Reply to Anonymous Referee #1

Vigouroux and co-authors present extensive validation of TROPOMI's formaldehyde retrievals (version 1.1.[5-7]) against ground-based FTIR retrievals from 25 stations around the world. Most of this stations belong to the Network for the Detection of Atmospheric Composition Change (NDACC). Their results indicate that TROPOMI satisfies pre-launch precision and accuracy requirements. TROPOMI overestimates HCHO columns (~26%) over locations with small HCHO levels while underestimates HCHO columns (~30%) over locations with high HCHO levels.

Figure 1: Median bias at each station for the different collocation distances. The numbers in black are the number of coincidences, from the 10km criterion (top) to the 50km criterion (bottom).

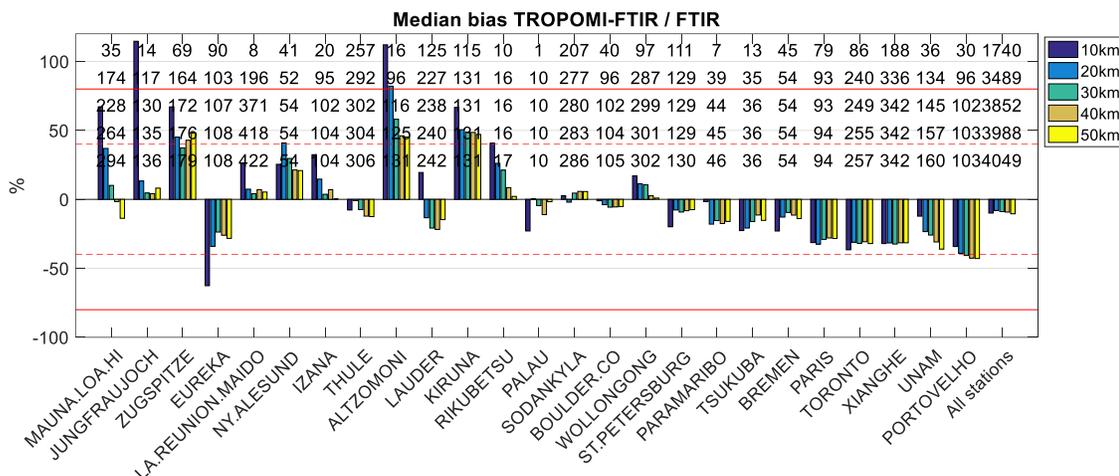
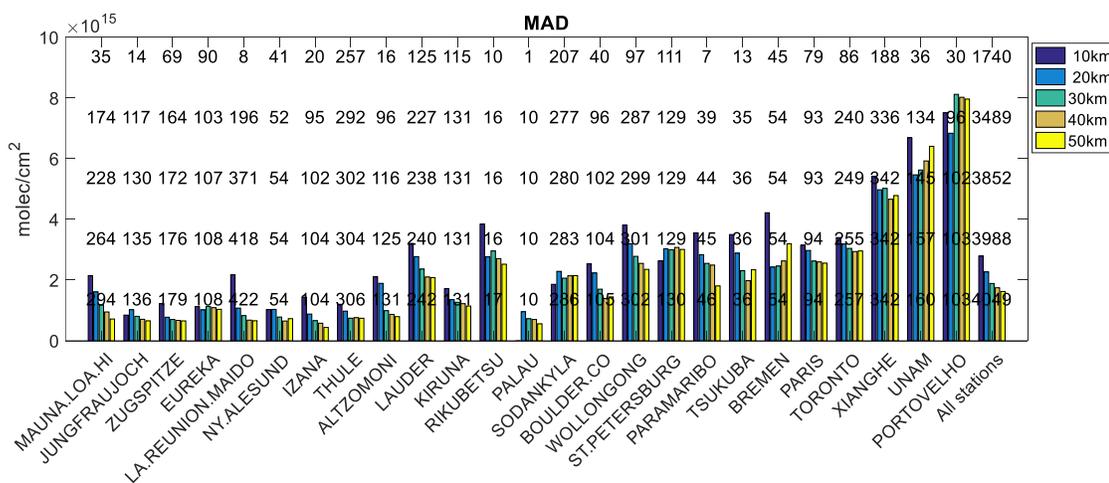
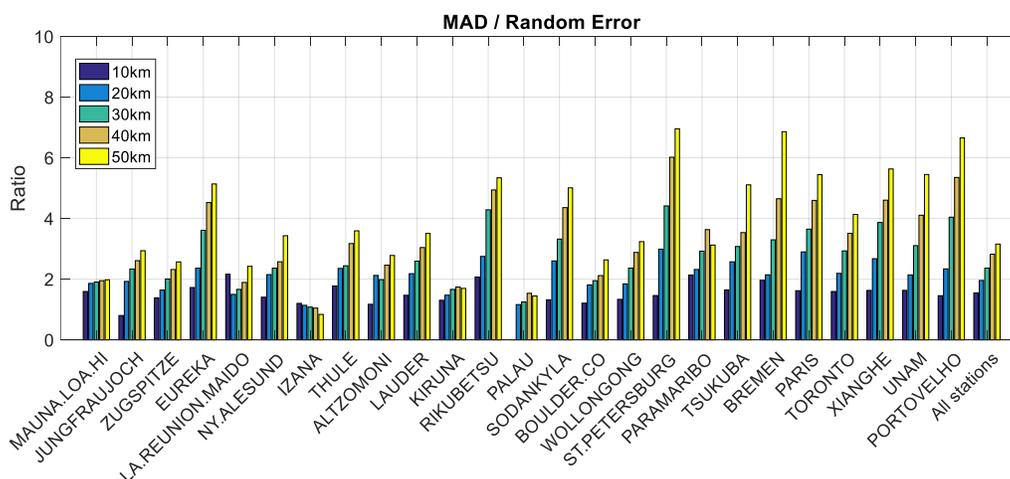
What is the effect of reducing/increasing the TROPOMI/FTIR collocation radius (currently set at 20km)? Is there a radius threshold/range where no improvement is achieved in the comparisons?

Before choosing the 20km collocation radius, we have indeed tested several distances: 10, 20, 30, 40, and 50 km. We provide in this discussion a plot of the median relative differences (bias) at each station (Fig.1) for the different collocation distances. Please, note that the numbers are not the same as in the AMTD paper, because this work on collocation distances were made in the course of the project (not at the time of writing the paper), so the time-series were shorter, and the collocated time was 6h (now it is set to 3h). We see in Fig. 1, usually similar biases for the 20 to 50 km criteria, especially for mid- HCHO levels sites. For clean sites, we observe usually slightly smaller biases with the 30km criteria than with the 20km one. For the most polluted sites, UNAM (Mexico City) and Porto Velho, the bias is increasing with the distance. The 10km collocation leads to more than twice less coincidences (at some stations, even 5 times less).

Therefore, the median biases obtained with this criterion were less robust, and the 10km choice was discarded.

The median biases, being usually similar using the different collocation distances, were not so useful to determine our choice of collocation. We therefore looked at the MAD (median absolute deviation, see Eq. 6 for complete definition) to help for the choice. Figure 2 shows the MAD at each station for the different collocation distance.

We see from the figure that usually the MAD is decreasing with the distance increasing, except at a few cases (the polluted cases as expected: Porto Velho, UNAM=Mexico City,...). However, we cannot conclude that the comparisons are “improved”: indeed, while the MAD is decreasing due to the averaging of more TROPOMI pixels, the random uncertainties of the comparisons are also decreasing. In a world where the random error would be perfectly determined, we would have a constant ratio MAD / RandErr (no dependence on the collocation distance), equal to 1 if

there is no collocation effect (so expected to be 1 at clean sites). If we plot this ratio (Figure 3), we see that it is increasing with the distance, pointing to an additional random error due to the collocation.

As no clear threshold provides an improvement of the comparisons, we therefore decided to use the 20km collocation choice, a good compromise between the number of coincidences, and the best correspondence between MAD and random uncertainty budget. It also avoids an increasing MAD over the highest HCHO level sites (UNAM, Porto Velho).

“Before choosing the 20 km collocation criteria, we have tested several distances (10, 20, 30, 40, and 50 km). The 10 km criterion was discarded because of the poor remaining coincidences leading to less robust statistics. The 20 to 50 km criteria give similar biases between TROPOMI and FTIR. The standard deviations of the comparisons usually decrease slightly with increasing collocation distance due to a smaller TROPOMI random uncertainty (more pixels to average), except at the most polluted sites. However, the ratio between the standard deviations and the random uncertainty budgets is increasing with the collocation distance at all sites, pointing to an increased random error due to the collocation. We therefore choose the 20~km distance to reduce the random spatial collocation error.”
